# Downtown Library Elevator Replacement

Contract No. E13-111

ADDENDUM NO.: FOUR <u>CURRENT DEADLINE FOR BIDS</u>:

October 10, 2012

Sheet Title SECTIONS AND DETAILS Scale Designed CMG Drawn DRD Date 10/8/12 Checked CMG

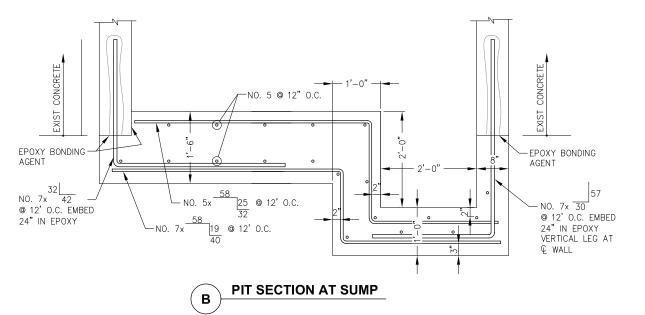
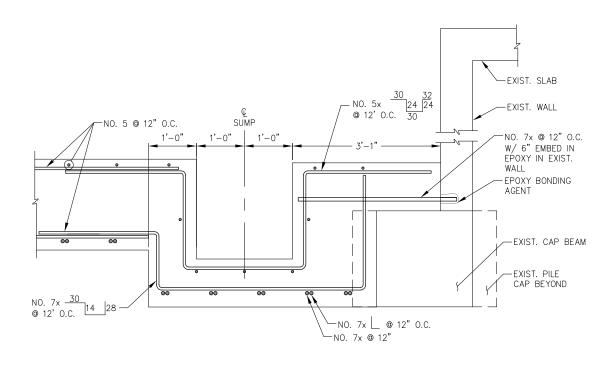
- Item No. 7 Sheet S2 Demolition Plan and Pit Floor Plan. *Add* the following note near dimension of concrete pit, "Based on record drawings. Field verify."
- Item No. 8 **Add** Sheet S3A Sections and Details, Elevator Pit modification and reinforcement for alternate elevator, issued October 8, 2012 by PND Engineers, Inc., labeled Addendum No. 4
